RESPONSE TO COMMENTS ON CRYSTAL RIVER UNIT 3 UPRATE PROJECT SITE CERTIFICATION APPLICATION

August 2007

**RESPONSE TO COMMENTS
ON
CRYSTAL RIVER UNIT #3 UPRATE PROJECT
SITE CERTIFICATION APPLICATION**

FIGURE 1
Average Intake Monthly Temperatures
(Pre and Post-Uprate Conditions)

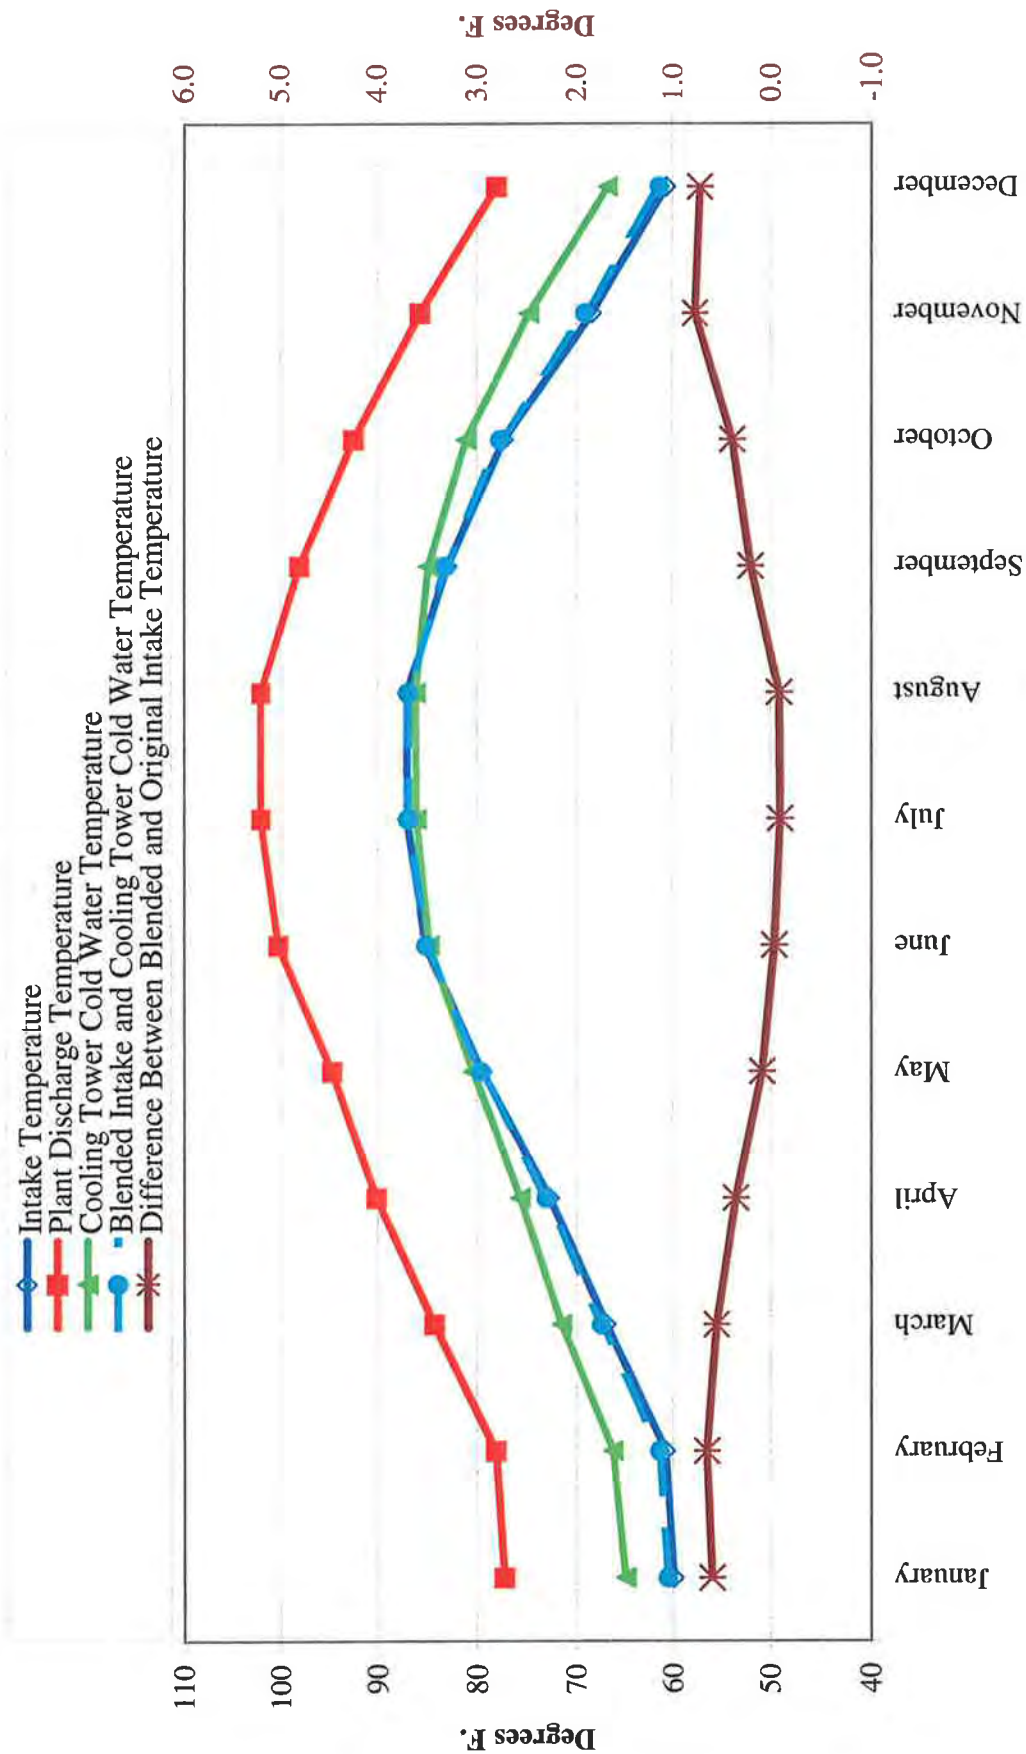
12. The applicant has stated that there will be no net increase in thermal effluent into the Crystal Bay estuary. Please provide supporting information to substantiate this claim.

shows the future SCT cold water temperature which will be recirculated to the intake canal, and the resulting blended temperature of the SCT's recirculating cells combined with the intake water. It shows that in no case does the SCT cooling tower discharge to the intake canal cause the three Units' intake temperature to increase by as much as one degree F. In fact, during summer months of July and August, the cooling tower cold water is predicted to actually reduce the Units' intake temperature slightly. Figure 1 displays the results of Table 1 graphically.

FIGURE 8
Post-Uprate Circulating Water Flow Rates

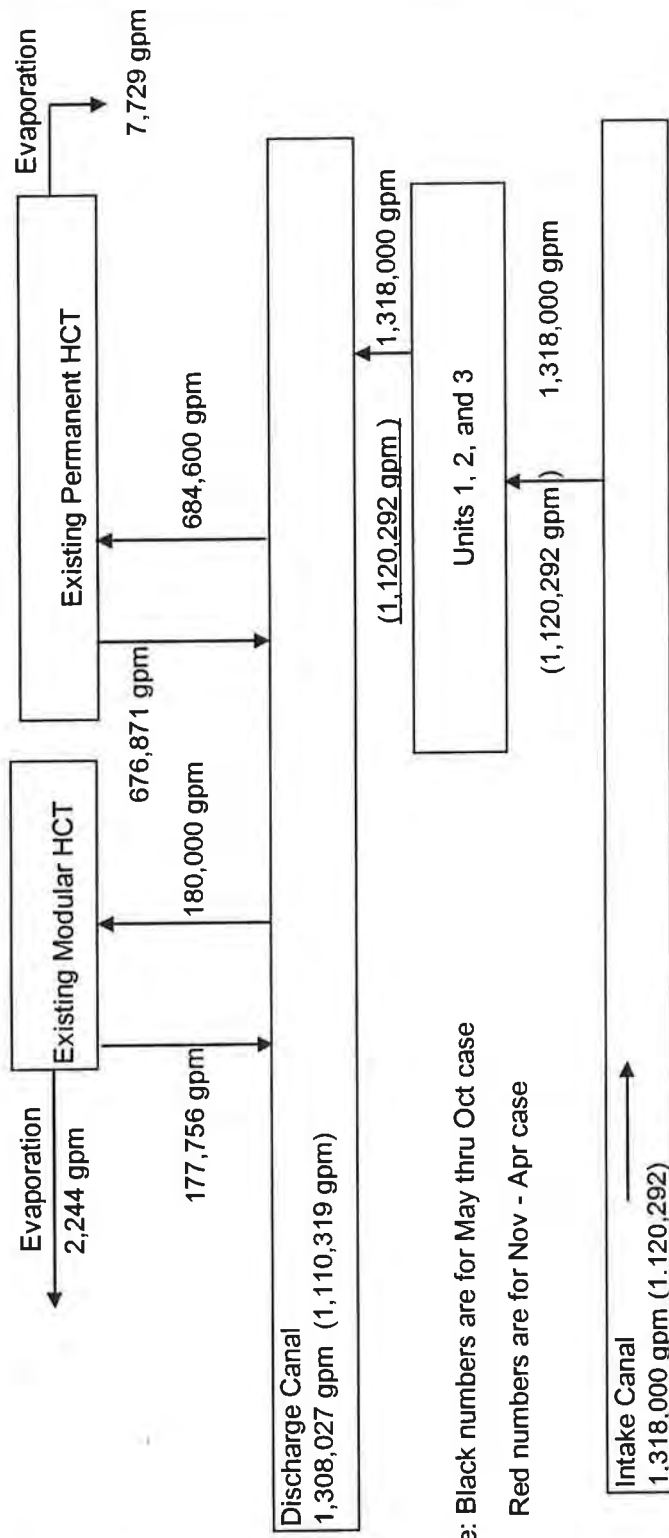
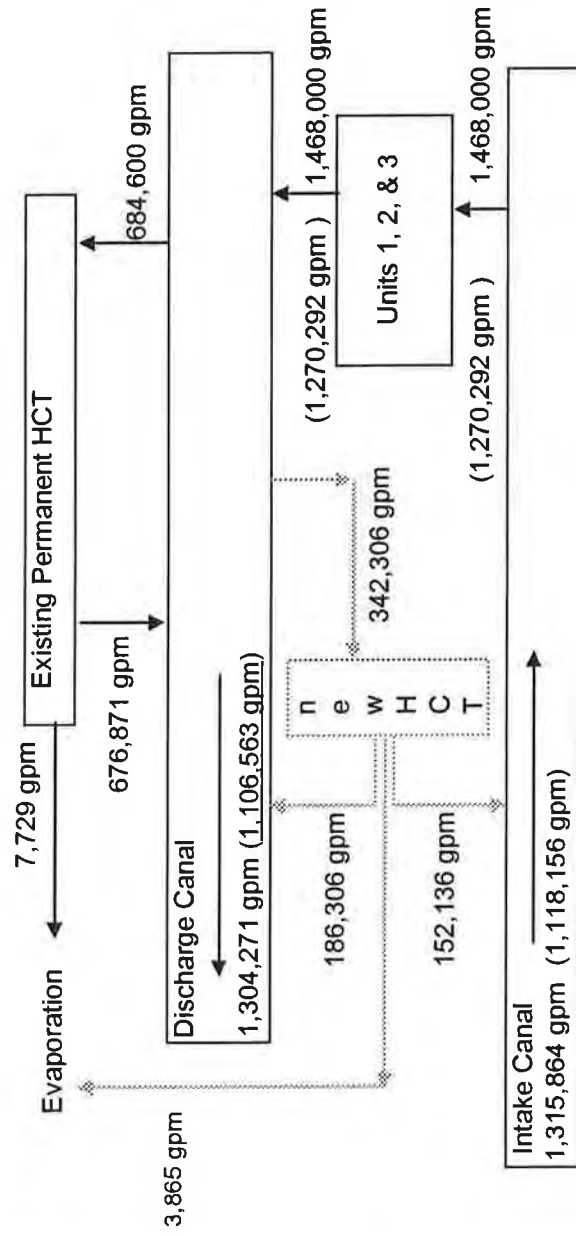
11. Progress Energy has stated that the amount of water proposed to be withdrawn from Crystal Bay will be the same volume as currently utilized by the existing infrastructure. They have made assertion that there will be no increase of water withdrawn from Crystal Bay estuary due to facility upgrades and use of new improved technologies. Please provide supporting information to substantiate this claim.

1. **Figure 3.5.1-1 of the application indicates that the once through cooling water discharge from Crystal River Units 1, 2 and 3 has a flow rate of 1,304,271 gpm (or 1878 MGD). However, the facility has a flow limitation of 1,613.2 MGD during November through April. Please explain.**

Figure FDEPSW-11-1 (attached) shows the flow diagrams for the pre-uprate and post-uprate

cases. The existing NPDES permit limits the flow through the three units (1, 2, and 3) to 1,318,000 gpm (1,897.9 MGD) during the months May through October, and 1,132,792 gpm (1,613.2 MGD) during the months November through April. These are shown in the top diagram of Figure FDEPSW-11-1 labeled "Pre-Uprate". The existing flow from Crystal Bay to the plant is shown under the words "Intake Canal" as 1,318,000 gpm during May through October and 1,132,792 (in red) during November through April. The diagram assumes that the existing Helper Cooling Towers (HCT) are operating; however, the flow from Crystal Bay is the same whether the HCT operate or not.

The lower diagram in Figure FDEPSW-11-1 shows the estimated plant flow rates after the uprate is complete and the SCT is operational. This diagram assumes the largest potential increase in the circulating water flow rate of 150,000 gpm resulting in flow through the three units of 1,468,000 gpm during the months of May through October, and 1,270,292 gpm during the months of November through April. The conceptual design of the SCT requires that the southernmost 8 cells operate year-round in the recirculating mode, whenever all three units are operating, in order to avoid any increase in discharge temperature or heat rejected to Crystal Bay, and to avoid any increase in flow withdrawn from Crystal Bay. In the Post-Uprate diagram shown in Figure FDEPSW-11-1, it has been assumed that the remaining 10 cells will be operating in the helper cooling tower mode in order to continue to meet the NPDES limits on rolling average discharge canal exit temperature. The 152,136 gpm that is recirculated from the new SCT 1 will be discharged to the intake canal via a diffuser to ensure that it is well-mixed with the incoming flow from Crystal Bay. As shown on the diagram, this recirculation of 152,136 gpm will reduce the amount of water withdrawn from Crystal Bay to 1,315,864 gpm during May through October, and to 1,118,156 gpm during November through April. Both of these withdrawals are reduced from the pre-uprate case and comply with the existing permit limits.

Response: Comment acknowledged. Figure 3.5.1-1 depicts the water use diagram during the months May through October and is comparable to SCA Figure 2.3.4-4 for the existing facility. Please see the response to A-FDEPSW-11 and the associated Figures 7 and 8 for the updated water use diagrams for both the existing and proposed facilities.
